## MINERALS PROGRAM INSPECTION REPORT

<b>MINE NAME:</b> Boettcher Limestone Quarry	<b>MINE/PROSPECTING ID#:</b> M-1977-348	<b>MINERAL:</b> Limestone (general)	<b>COUNTY:</b> Larimer
<b>INSPECTION TYPE:</b> Monitoring	<b>INSPECTOR(S):</b> Amy Eschberger, Eric Scott	<b>INSP. DATE:</b> August 16, 2017	<b>INSP. TIME:</b> 15:55
<b>OPERATOR:</b> Holcim (US) Inc.	<b>OPERATOR REPRESENTATIVE:</b> Mike Toelle	<b>TYPE OF OPERATION:</b> 112c - Construction Regular Operation	
<b>REASON FOR INSPECTION:</b> Normal I&E Program	<b>BOND CALCULATION TYPE:</b> None	<b>BOND AMOUNT:</b> \$2,518,261.30	
<b>DATE OF COMPLAINT:</b> NA	<b>POST INSP. CONTACTS:</b> None	<b>JOINT INSP. AGENCY:</b> None	
<b>WEATHER:</b> Clear	<b>INSPECTOR'S SIGNATURE:</b> 	<b>SIGNATURE DATE:</b> June 7, 2018

TITLE  
**PROPERTY, PERMIT, AND PRE-81 AREAS  
OVER CURRENT AERIAL IMAGERY**

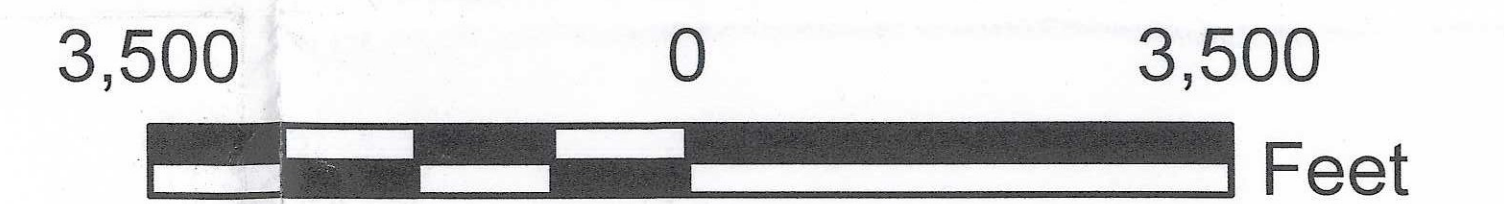
The Division observed water ponded in three of the pits located along the western half of the permit area, and in two of the pits located along the eastern half of the permit area. According to permit documents, the three western pits observed holding water are referred to as Pond A, Pond B3, and Pond B (see enclosed map showing labeled ponds). The pit referred to in the file as Pond B2 was not holding water during the inspection. The two eastern pits observed holding water are referred to in the permit file as Pond 2 and Pond C. The Division of Water Resources (DWR) requires operators to ensure water is not retained on site for more than 72 hours, unless an augmentation plan approved by water court is obtained. An augmentation plan must also be obtained for any exposed groundwater, unless an exemption has been approved by DWR. The operator has copied the Division on several letters submitted to the DWR/Office of the State Engineer (SEO) demonstrating the operator was working to obtain compliance with their Office. However, the Division is unable to find any documentation in the permit file proving the operation ever gained compliance with the DWR/SEO for the ponded water. Pursuant to Rule 3.1.6(1)(a), the operator must maintain compliance with applicable Colorado

water laws and requirements governing injury to existing water rights. Therefore, the Division is citing a Problem in this report for the ponded water, giving the operator 60 days to demonstrate the operation is in compliance with the SEO, show evidence the operator is taking measures to bring the site into compliance with the SEO, or backfill the pits to at least two feet above the groundwater surface.

**CORRECTIVE ACTIONS:** The operator shall demonstrate that the operation is in compliance with the Office of the State Engineer (SEO), show evidence that the operator is taking measures to bring the site into compliance with the SEO, or backfill the pits to at least two feet above the groundwater surface by the corrective action due date.

# M-1977-348 / Boettcher Limestone Quarry / Holcim (US) Inc.

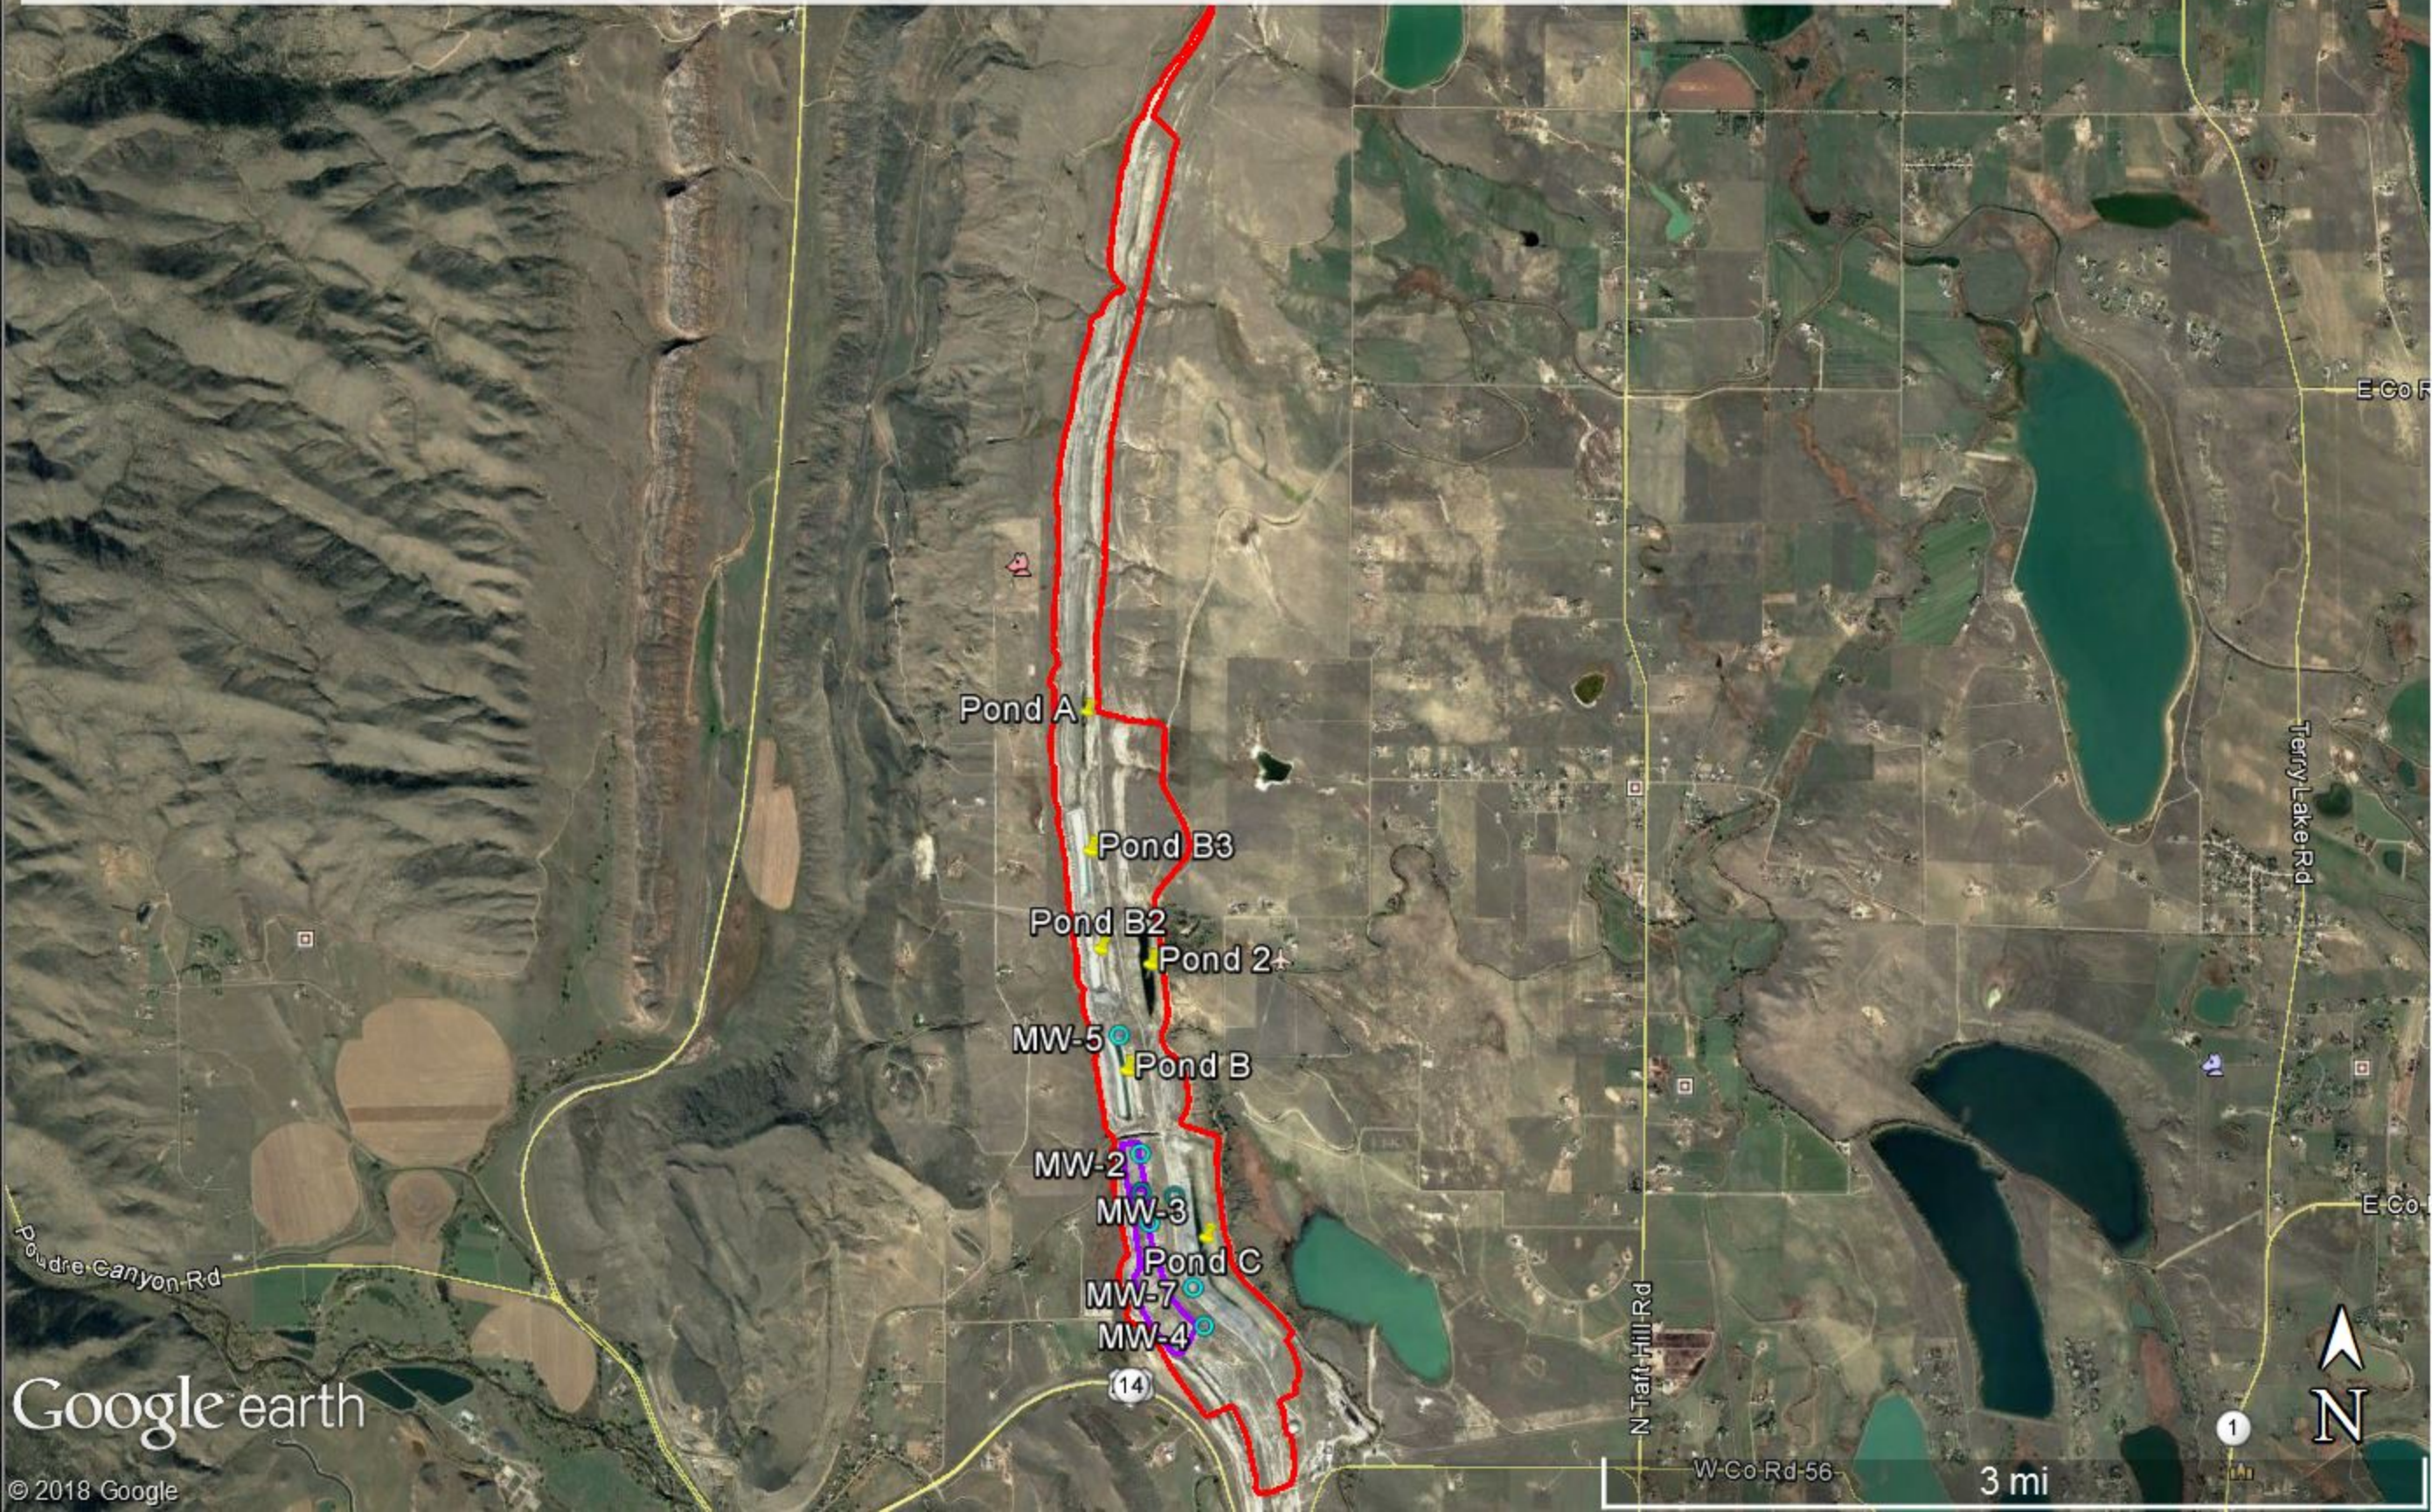
The operation monitors groundwater at the site from seven monitoring wells, with all but one located near or downgradient of the CKD disposal area in the southern portion of the permit area. Monitoring wells MW-1, MW-2, MW-3, and MW-4 were installed in 1998 and 1999. Monitoring wells MW-5, MW-6, and MW-7 were installed in late 2012. It appears that groundwater monitoring was not conducted regularly at the site until 2010/2011, from the first four monitoring wells. The additional three monitoring wells installed in 2012 have been monitored regularly since 2013. The permit file does not include groundwater monitoring data prior to the disposal of CKD on site. After the Division's approval of Technical Revision No. 6 (TR-6) in 2014, monitoring parameters were reduced to include: Barium, Boron, Iron, Manganese, pH, Total Dissolved Solids (TDS), Alkalinity, Calcium, Chloride, Magnesium, Potassium, Sodium, and Sulfate. Approval of Technical Revision No. 7 in 2016 reduced the required monitoring (and reporting) frequency from quarterly to semi-annually. This was to allow for complete recharge between sampling events, so that true independent measurements are collected based on groundwater equilibrium conditions.

In review of the permit record for this site, the Division found a clerical error with regard to the permitted acreage entered into the permit system, specifically, for Acreage Reduction No. 1 (AR-1), which should have left a permit area of 862 acres. It appears this acreage reduction was not properly entered into the permit system, as it still showed a permit area of 1,848 acres. To correct this clerical error, the Division issued an Administrative Revision (AD-2) on June 1, 2018 to change the permit area from 1,848 acres to 862 acres (see enclosed notification of Administrative Revision No. AD-2). This revision does not change the approved permit boundary, but corrects the permit acreage to match what was released in AR-1. Enclosed with this report are two Google Earth images of the site showing the approved permit area, along with other features discussed in the report.
